**DEVIATION REQUEST  
AND DECISION FORM**  
(Judge Orr Deviation)  
Updated: 6/26/2019

Project Name : Monument Ridge East  
Schedule No.(s) : 7102200013, 7102200006, 7102200010  
Legal Description : TRACT OF LAND IN N2 SEC 02-11-67 DESC AS FOLS, COM AT NE COR OF SD SEC, TH S 89<06'54" W 1320.00 FT, S 00<53'12" W 30.00 FT FOR POB, TH S 89<06'54" W 1834.51 FT TO PT ON ELY R/W LN OF I25, TH ALG SD R/W S 29<33'00" W 180.19 FT, S 89<05'00" W 500.00 FT, S 29<16'30" W 675.30 FT, S 06<43'00" W 36.92 FT, S 89<57'36" E 251.71 FT, S 06<43'00" W 337.98 FT, S 89<57'36" E 732.00 FT, TH N 14<12'38" E 887.45 FT, N 89<06'34" E 500.0 FT M/L, N 00<02'24" W 270.0 FT, S 89<06'54" W 650.0 FT M/L TO POB, EX PT DES AS FOLS: TR OF LAND IN NW4 SEC 2-11-67 DES AS FOLS: COM AT NE COR OF SD SEC 2, TH S 89<06'54" W ALG N LN OF SEC 2 A DIST OF 2879.42 FT, TH ON A DEFLECTION ANGLE TO THE L OF 90<00'00" 50.00 FT TO A PT 20.00 FT S OF EXISTING SLY R/W LN OF COUNTY LINE RD FOR POB, TH N 89<06'54" E 105.00 FT, S 13<48'06" W 130.00 FT, S 89<06'54" W 175.76 FT SLY OF S R/W LN OF SD RD A DIST OF 105.00 FT, N 13<48'06" E 130.00 FT TO POB, EX THAT PT CONV BY REC #210120918, EX THAT PT TO COUNTY CONV BY REC #214002145.

*

Deviation No. 1 - Exhibit 1

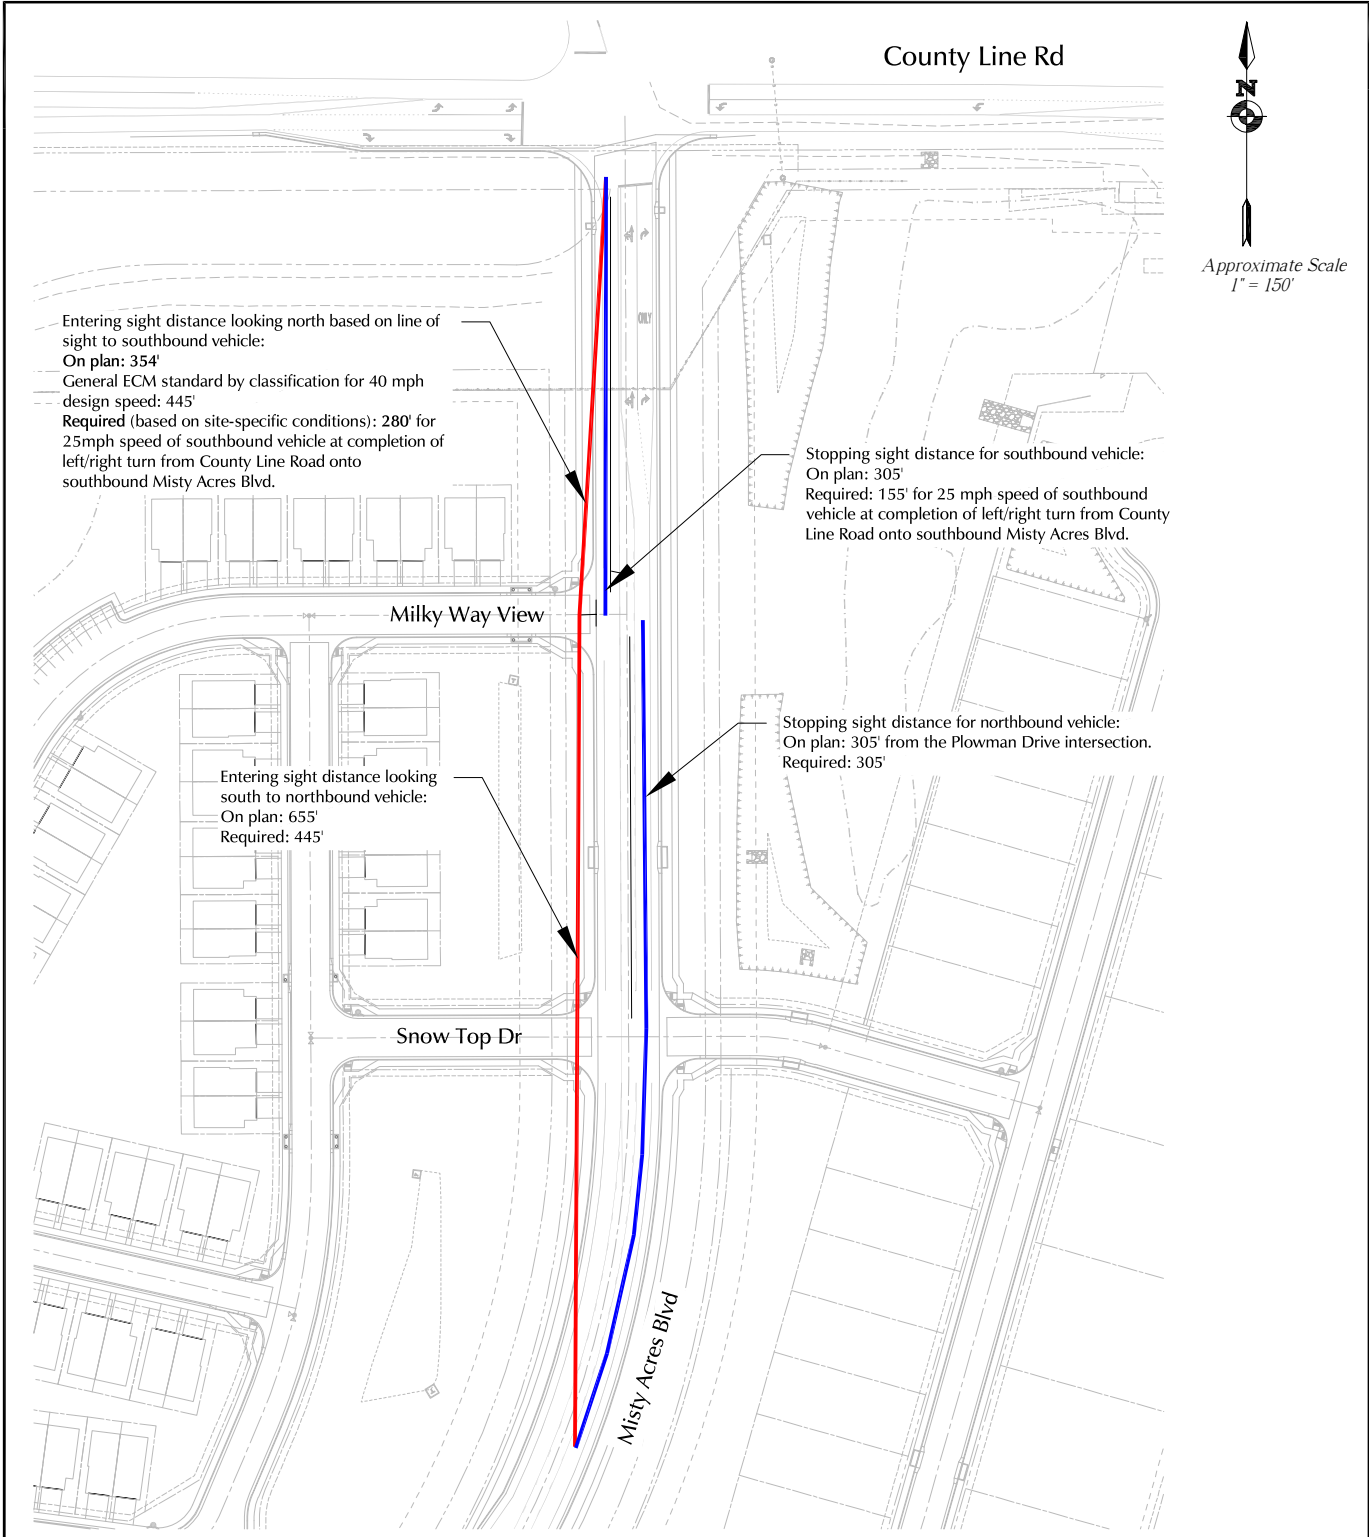
Deviation request is to allow the proposed north access point location: Milky Way View to the planned extension of Misty Acres Boulevard. This deviation involves the intersection spacing of Milky Way View 395 feet to the north to the future County Line Road/Misty Acres Boulevard intersection.

The deviation is requested as the proposed intersection spacing between County Line Road and the proposed Milky Way View is less than the prescribed 660 feet along the future alignment of Misty Acres Boulevard.

As the adjacent intersection to the north is an Arterial (County Line Road), the standard requires an intersection centerline spacing of 660 feet. Centerline spacing on Misty Acres Boulevard between County Line Road and the Milky Way View would be 395 feet (see Deviation Exhibit 1).
